**MONTGOMERY COUNTY HISTORIC PRESERVATION COMMISSION**  
**STAFF REPORT**

<b>Address:</b>	7417 Baltimore Ave., Takoma Park	<b>Meeting Date:</b>	12/16/2020
<b>Resource:</b>	Contributing Resource <b>Takoma Park Historic District</b>	<b>Report Date:</b>	12/9/2020
<b>Applicant:</b>	Benjamin and Jess Bregman	<b>Public Notice:</b>	12/2/2020
<b>Review:</b>	HAWP	<b>Tax Credit:</b>	partial
<b>Case No.:</b>	37/03-20AAAAA	<b>Staff:</b>	Dan Bruechert
<b>Proposal:</b>	Porch Alterations

Figure 5: Roof framing showing the existing (left) and the proposed (right) and the intersection of the roof planes.

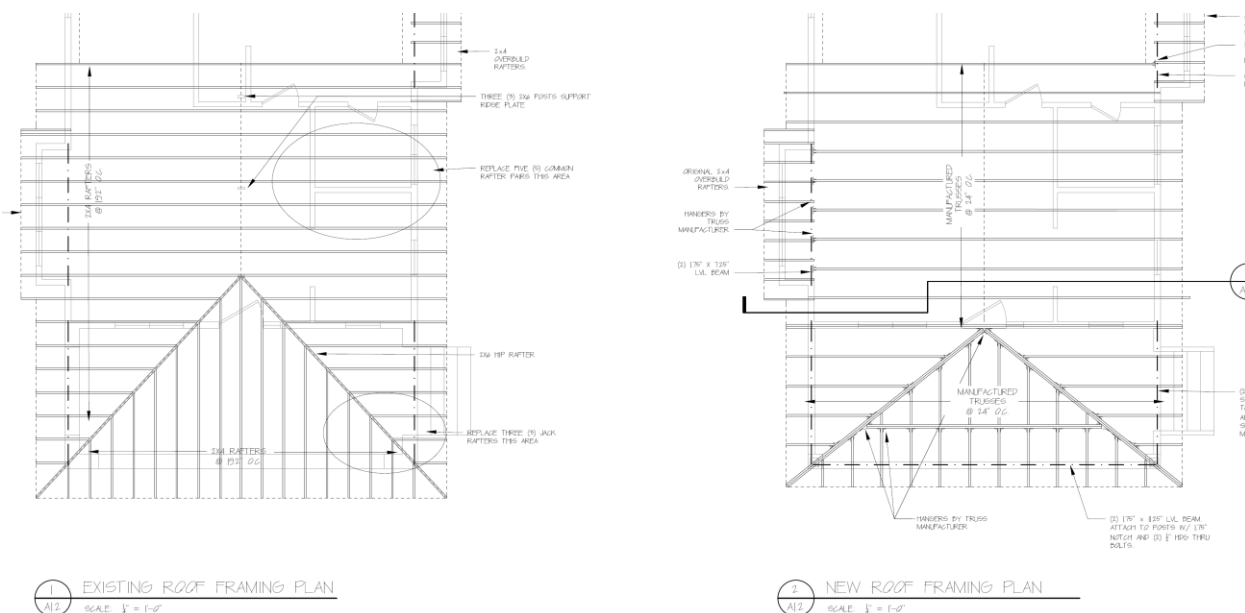
First, the applicant proposes to change the front roof slope. The existing roof framing has been found to be insufficient. Currently, the hip intersects two rafters to the rear of the front wall plane. The new proposal has a slightly steeper pitch on the front roof plain so the hip is directly above the front wall plane. This placement will utilize the front wall framing to provide additional support for the porch roof.

Staff finds that while this change will alter the roofline, the slope will have a lower pitch than the surrounding houses, it will still stand out as a Prairie design; thereby retaining the character-defining importance of this element. Staff supports approval of the change to the roof pitch under 24A-8(b)(2) and (d).

3 PROPOSED NEW PORCH ELEVATION  
SCALE: 1/4" = 1'-0"

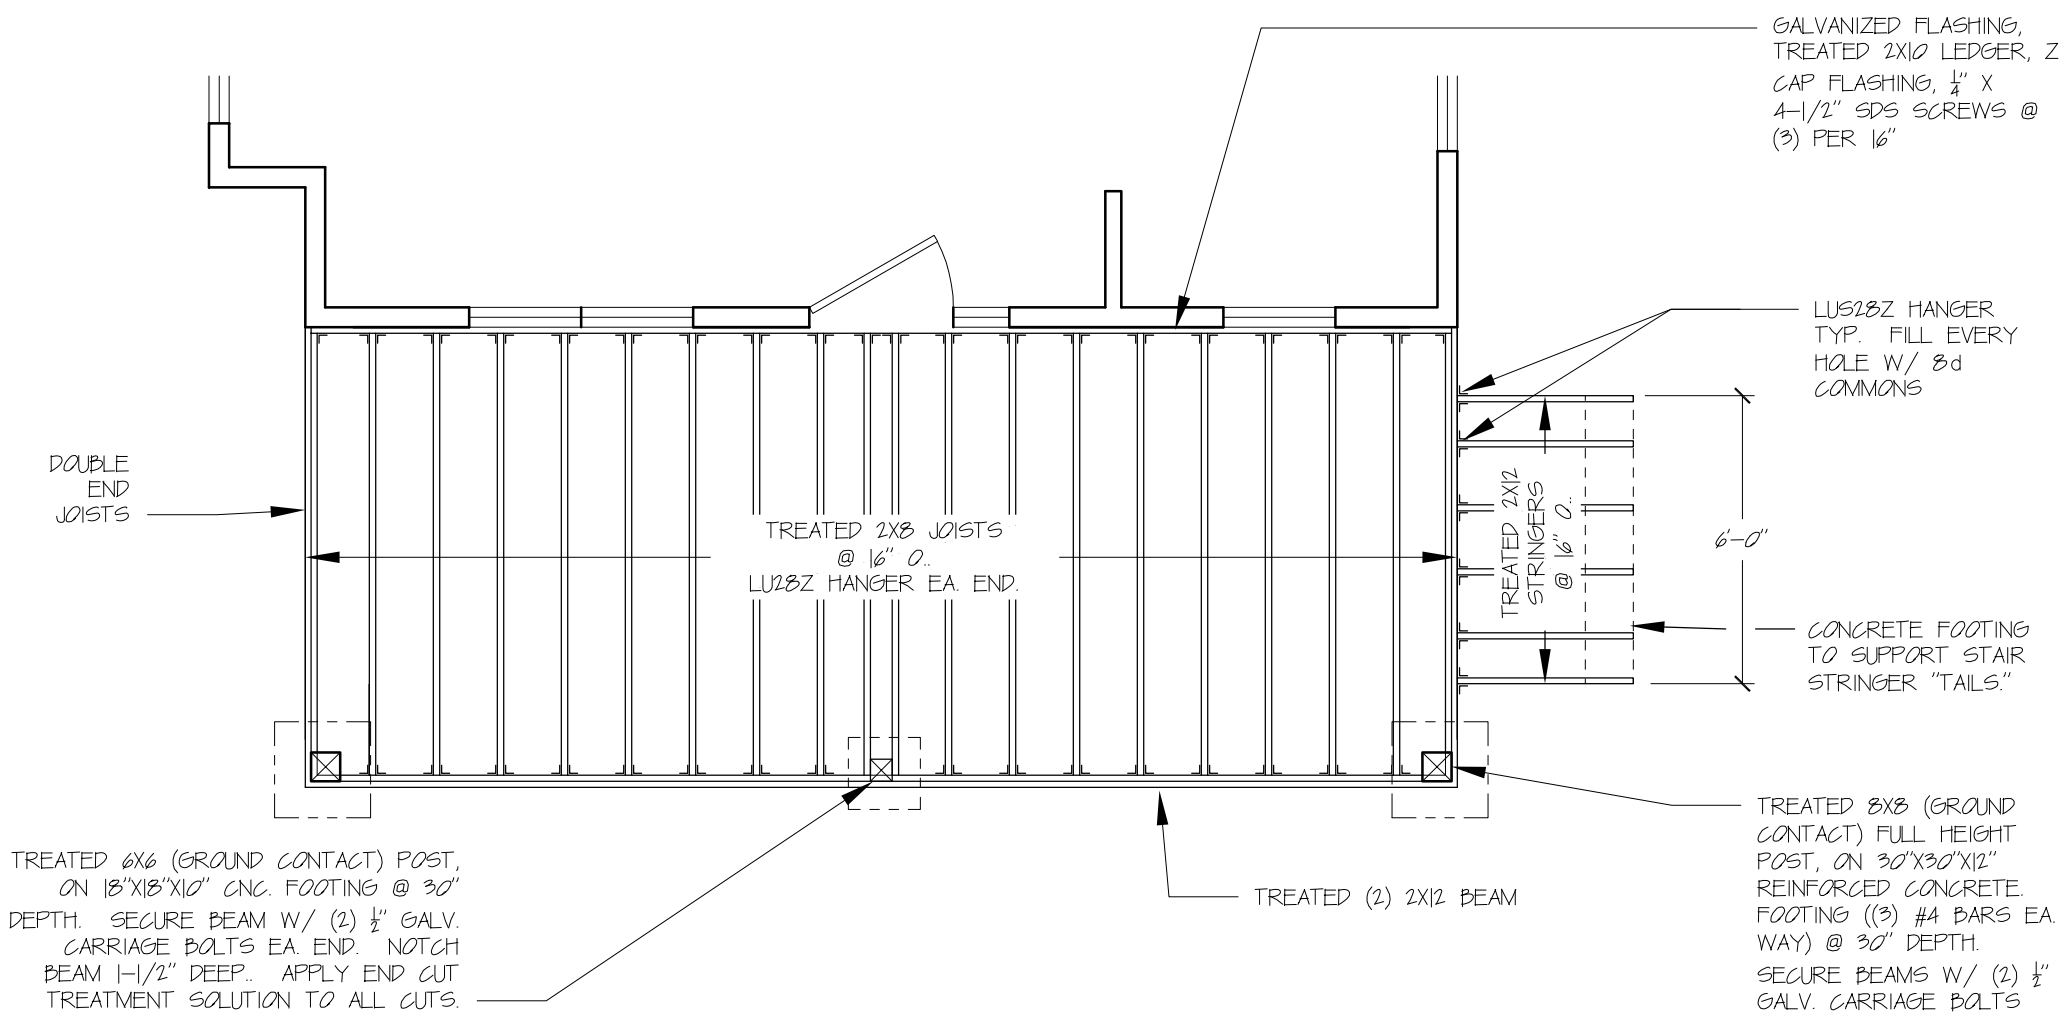
1. The full height of the front porch columns needs to have a stucco finish with straight sides, eliminating the battered design. Staff will verify this condition has been met upon submission of the permit set of plans.

Finally, the applicant proposes changing the porch columns. The existing columns are large square stucco columns with low openings under the beams. The applicant proposes to construct smaller columns, with square stucco bases and battered wood columns and to eliminate the stucco under the porch beams. Staff finds that the battered columns are more in keeping with a Craftsman-style house and while Craftsman and Prairie architecture share several elements, Staff does not find this to be a compatible alteration. Staff recommends the HPC include a condition on the approval that the full height of the front porch columns have a stucco finish with straight sides, eliminating the battered element. Staff will verify that this condition has been met when the permit drawings are submitted for review and stamping.

1. The full height of the front porch columns needs to have a stucco finish with straight sides, eliminating the battered design. Staff will verify this condition has been met upon submission of the permit set of plans;

Figure 3. Framing Plan

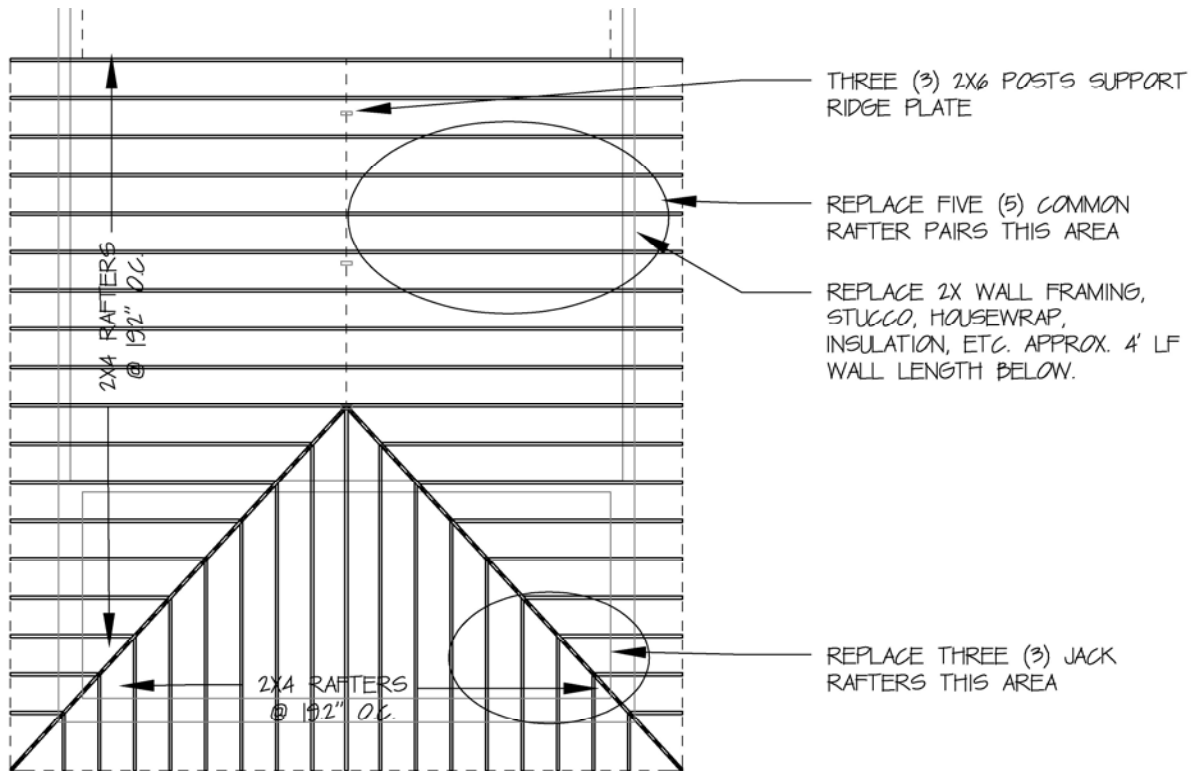
At the corner over the front porch steps, a very long (and also very undersized) 2x6 hip rafter supports 2x4 jack rafters, three (3) of which appear to be broken and/or knocked loose from the hip. The hip rafters themselves are supported by face nails to the ridge plate and rafters, which in turn rest on a 2x6 post and ceiling joist as described above. It was not possible to see whether or not the hip rafter may also have been cracked or broken, but it appeared intact. MacKay CS recommends replacing the jack rafters, along with roof decking above. Again, framing challenges are obvious: the hip rafter itself is very undersized, the peak of the roof is improperly supported, there are no hangers or hardware for the hips, among other problems which will need to be addressed in the repair drawings.

In order to properly support the hip rafters, and to prevent wind uplift, a solid new post should be installed at each corner. This post should rest on top of a properly sized footing, and should include hardware adequate to restrain  $\frac{1}{4}$  of the entire roof against uplift. Similarly, beams should be installed from the post back to the main house, and from post to post across the front, which are capable of supporting the full weight of the rafters which rest upon them, and which will resist withdrawal and wind uplift. The floor has not been assessed, as it does not appear to have been affected by the wind/tree damage which damaged the roof, but design and installation of the post must not make the floor support conditions worse.
